Re: Joint Permit Application – File No. 15-73-0003-P
EPA ID #MID 041 793 340
RACER Saginaw Nodular Iron Industrial Land - Saginaw, Michigan

Conestoga-Rovers & Associates (CRA) on behalf of Revitalizing Auto Communities Environmental Response (RACER) has prepared the following responses to the Michigan Department of Environmental Quality (MDEQ) comments received on March 17, 2015 on the Joint Permit Application (File No. 15-73-0003-P) for the work proposed in the North Ditch at RACER's Nodular Industrial Land (Site) in Saginaw, Michigan. The following Attachments are included as part of CRA's responses.

SUBJECT: CORRECTION REQUEST

NORTH DITCH PLAN AND PROFILE

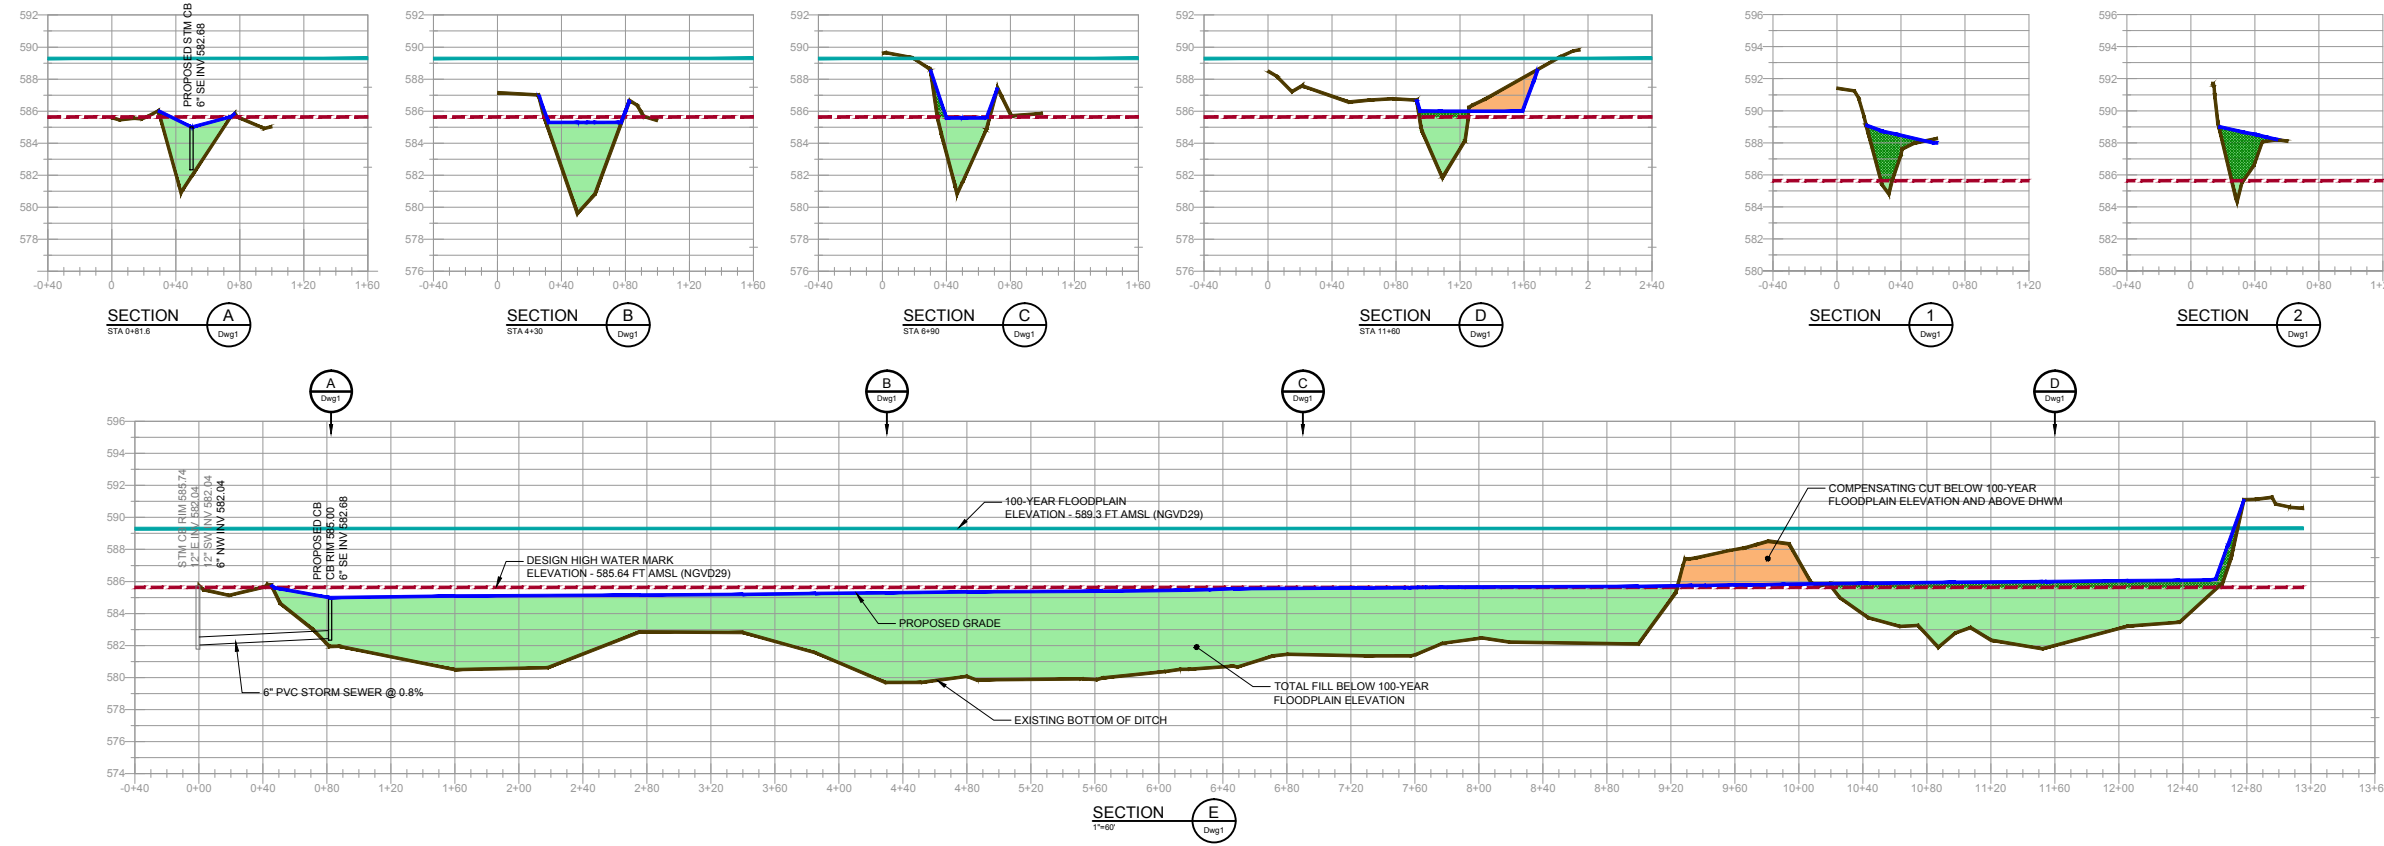
The vertical datum listed in the permit application in Section 10 is NAVD88. The vertical datum listed in the permit application in Section 13 is NGVD29. Drawing "Dwg1" states that the vertical datum is NGVD29/AMSL. Other plans drawings do not have a vertical datum listed. Only one vertical datum should be used throughout the submittal. Clarify the vertical datum used and provide conversions from any other datum when necessary. Include calculations and references.

The OHWM in drawing "Dwg1" is 585.64 ft AMSL. The OHWM in Section 10 of the permit application is 584.68 ft. NAVD88. Clarify the discrepancy and, if necessary, provide conversions with calculations and references.

Vertical datum NGVD29 was used in all the plans that were prepared. The vertical datum that was checked in Section 10 (NAVD88) of the permit was inadvertently selected and should have been checked as NGVD29.

The water elevation included in Section 10 of the permit was not the Observed High Water Mark (OHWM); it was a water level that had been measured on a specific date. Please note that the vertical datum in Section 10 was inadvertently checked as NAVD88, and should be checked as NGVD29. The OHWM (or the Design High Water Mark [DHWM] for the proposed work) is 585.64 ft AMSL (NGVD29).

REVITALIZING AUTO COMMUNITIES ENVIRONMENTAL RESPONSE (RACER)
 SAGINAW, MICHIGAN
 NORTH DITCH SECTIONS

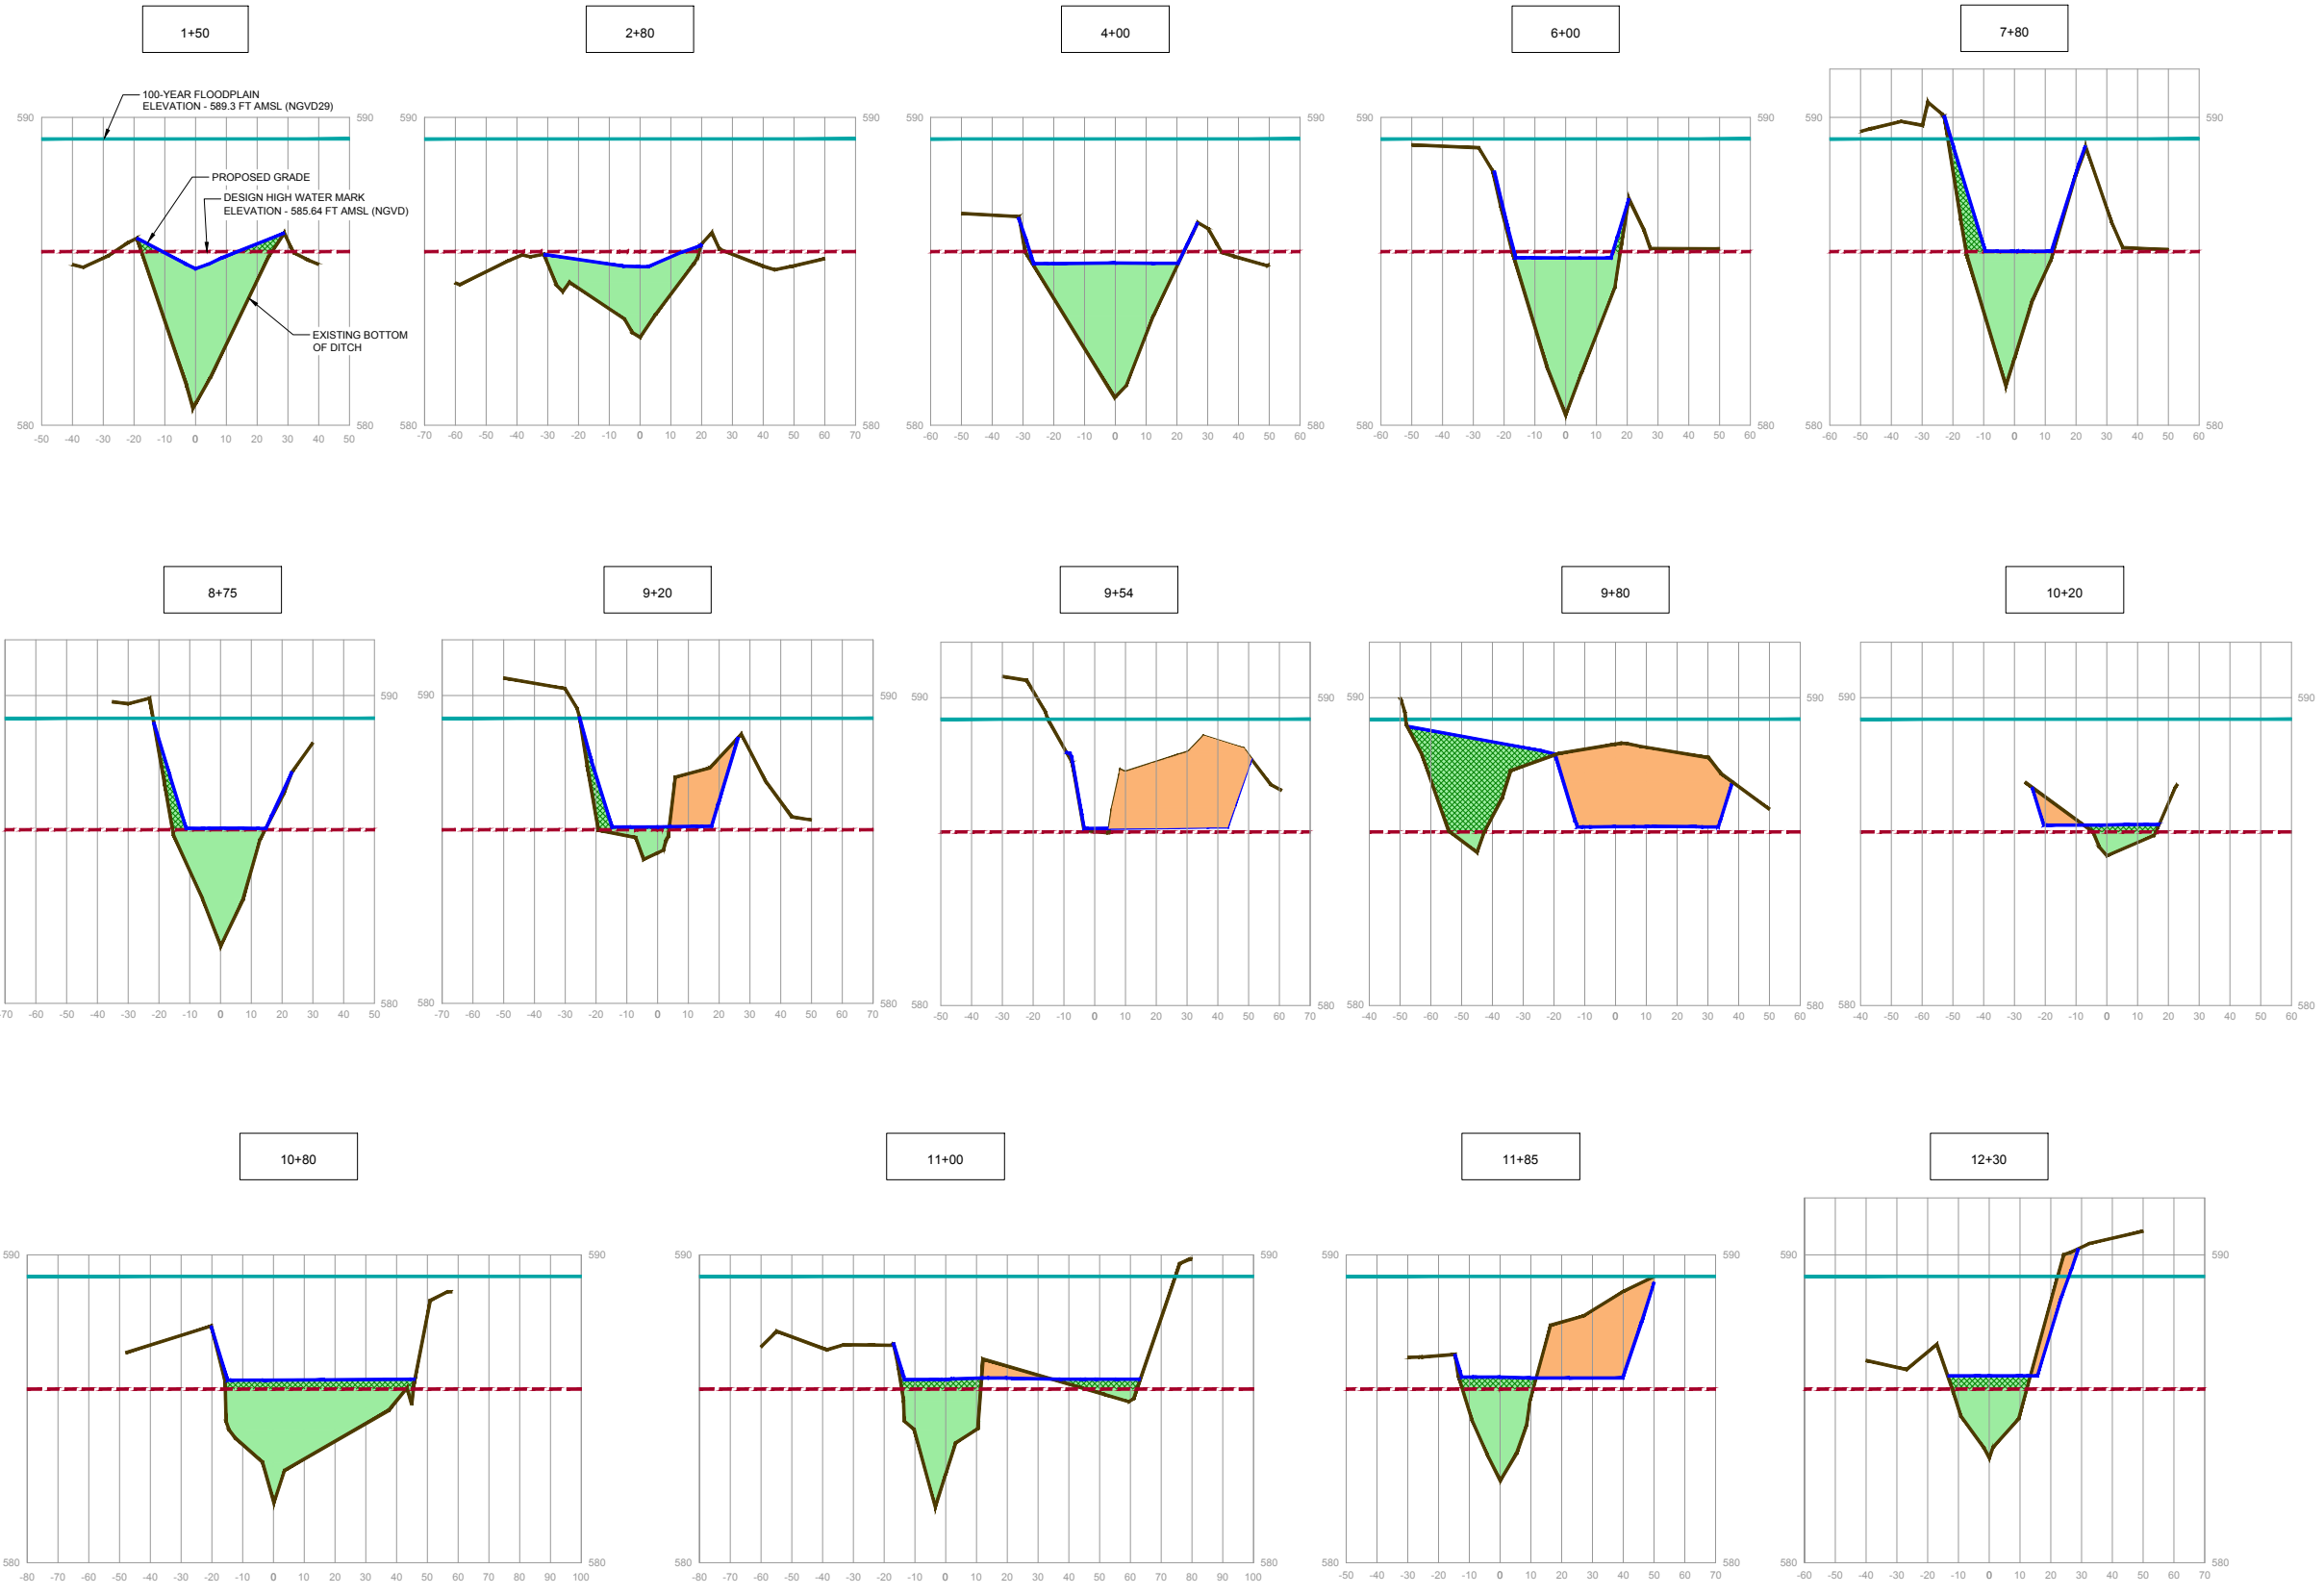
Provide calculations for determining both fill and cut volumes. Your application referenced a computer program. If no hand calculations were performed, provide access to the computer program so that volumes can be verified.

Attachment B presents the hand calculations of the cut and fill volumes above the DHWM (585.64 ft AMSL – NGVD29) and below the 100-year floodplain level (589.3 ft AMSL – NGVD29). Attachment C presents the cross-sections used for the cut and fill volume calculations.
